Application by Frodsham Solar Ltd for Frodsham Solar (EN010153)

The Examining Authority's second written questions and requests for information (ExQ2): Issued on 13 March 2026

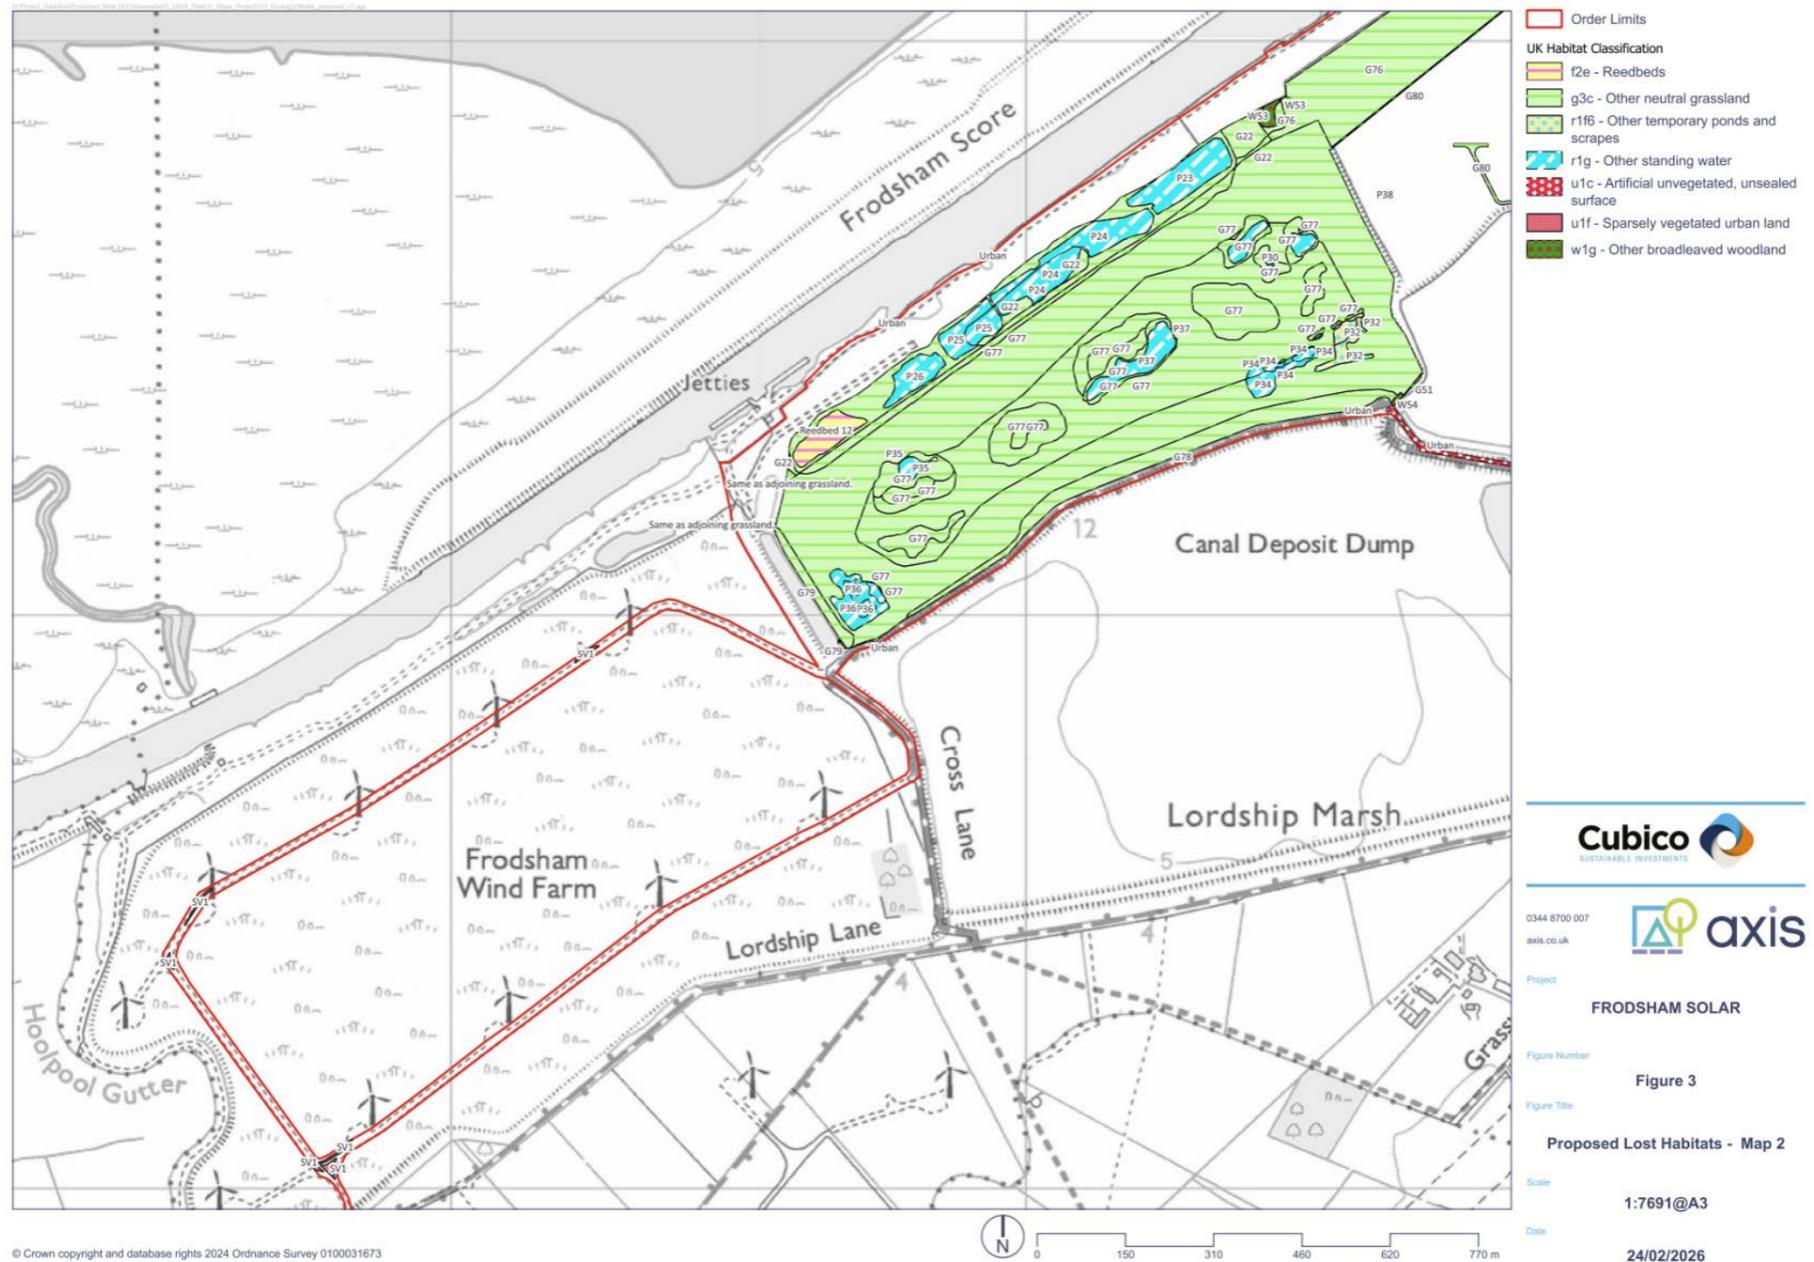
<p>2.4.4</p>	<p>Applicant</p>	<p>Trading rules – net loss of reedbed habitat</p> <p>The applicant states in section 6.3 of the deadline 4 Biodiversity Net Gain Report [REP4-038], that there would be a deficit of reedbed habitat type and scrub broad habitat type, see screen shot below.</p> <div style="border: 1px solid black; padding: 10px;"> <p><u>6.3 -Trading Rules</u></p> <p><u>6.3.1</u> There is a deficit of -10.95 units in reedbed habitat type required to achieve trading rules, which is a high distinctiveness habitat requiring the same habitat type to offset losses. Annex 3 discusses the baseline classification of reedbed.</p> <p><u>6.3.2</u> There is a deficit of -2.23 units of scrub broad habitat type required to achieve trading rules, which is a medium distinctiveness habitat requiring the same broad habitat type to offset losses.</p> </div> <p>Table 6.1 [REP4-038] provides a summary of area and unit change for each habitat type within the draft order limits. A screen shot is provided below for the first line concerning reedbeds.</p>

- 1) Can the applicant explain why post development there would be an increase in reedbed area but a decrease in reedbed units? What is it about the properties of the post development reedbed area that cause the calculation of resulting BNG units to fall?
- 2) The ExA acknowledges that BNG requirements are not yet mandatory for NSIP applications and that the applicant has clearly stated that the trading rules for reedbeds are not proposed to be met. Nevertheless, the mitigation hierarchy should still be adhered to. The ExA would like the applicant to explain how much reedbed is proposed to be lost for each of the areas given below and provide justification as to why these areas of reedbed are proposed to be lost and not retained:
 - a. Reedbed 12 shown in the NBBMA (see screenshot below from Map 2 of Figure 3 of the deadline 4 Biodiversity Net Gain Report [REP4-038])
